UNITED STATES PATENT AND TRADEMARK OFFICE

APPLICATION NO.	FILING DATE	FIRST NAMED INVENTOR	ATTORNEY DOCKET NO.	CONFIRMATION NO.
10/812,108	03/29/2004	Robert Lee Donovan	BA/Div App	1513
26860	7590	08/11/2006	EXAMINER	
LAW OFFICE OF DUNCAN PALMATIER 530 SOUTH ASBURY SUITE 5 MOSCOW, ID 83843			BURCH, MELODY M	
			ART UNIT	PAPER NUMBER
			3683

Office Action Summary

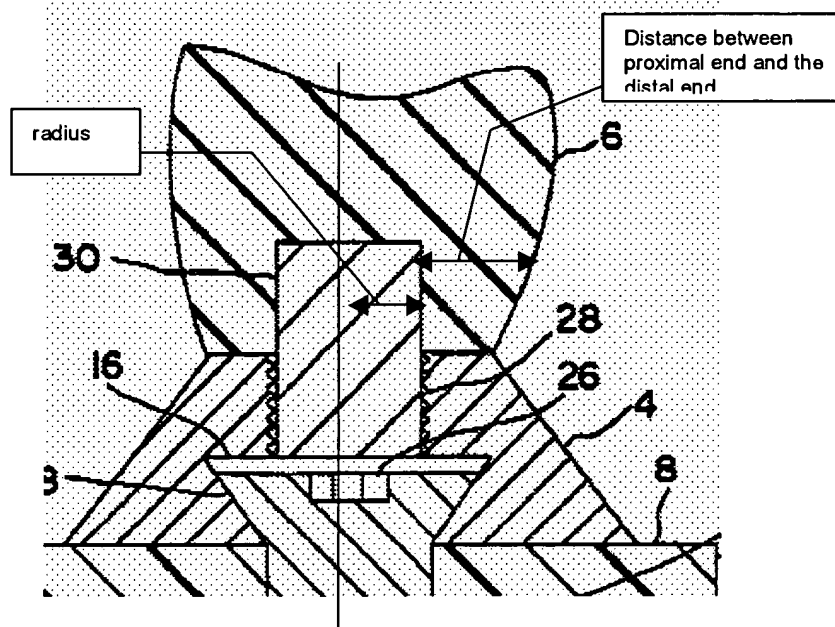
Re: claims 17 and 21. Graf shows in figures 1, 6, and 7a vibration damping device for an archery bow 22 comprising an archery bow with a cylindrical projection 16 as shown in figures 1 and 6, a vibration damper 17 formed of a single piece of elastomeric material as shown in figures 6 and 7 and disclosed in col. 4 lines 56-57 and having a cylindrical, ring shaped base with an inner cylindrical ring surface, and an axis along the length of the cylindrical ring shaped base and a radius from the axis to the inner cylindrical ring surface as shown in figure 7, the damper further comprising a plurality of fins shown between elements 31 in figure 7 extending from the ring shaped base in a radial direction from the axis, wherein each of the plurality of radial fins has a fin base at a proximal end of the fin at the ring base and a fin tip at a distal end of the fin, and wherein the radial fins are not constrained as shown and are free to vibrate and wherein the distance between the proximal end and the distal end of the fins is at least as great as the radius as shown in figure 7, and wherein the inner cylindrical ring surface fits over the cylindrical projection 16 of the archery bow. Graf shows 6 fins.

Re: claim 22. Graf shows in figures 1 and 6 a cylindrical projection 16 extending forward from the archery bow as shown in figure 1 wherein the inner cylindrical ring surface mounts to the cylindrical projection by way of intervening portions of element 17 as shown in figure 6 as best understood.

Applicant argues that the projections shown between elements 31 are not fins because Graf's invention inserts spring rods into elements 31. Examiner notes that regardless of whether recesses 31 are fitted with spring rods, the projections shown between the recesses 31 are properly considered to be fins. Applicant also argues that since the recesses are filled with spring rods, the fins are not constrained and free to vibrate. Examiner maintains that figure 7 shows the damper in a state in which its recesses are not filled with spring rods. Examiner maintains that at least in this state, the fins are not constrained and are free to vibrate. In response to Applicant's argument that it was improper to remove from consideration the rods 19, Examiner notes that Graf clearly shows the rods physically removed from the damper. Therefore, it is reiterated that in the state shown in figure 7, the fins are not constrained and are free to vibrate.
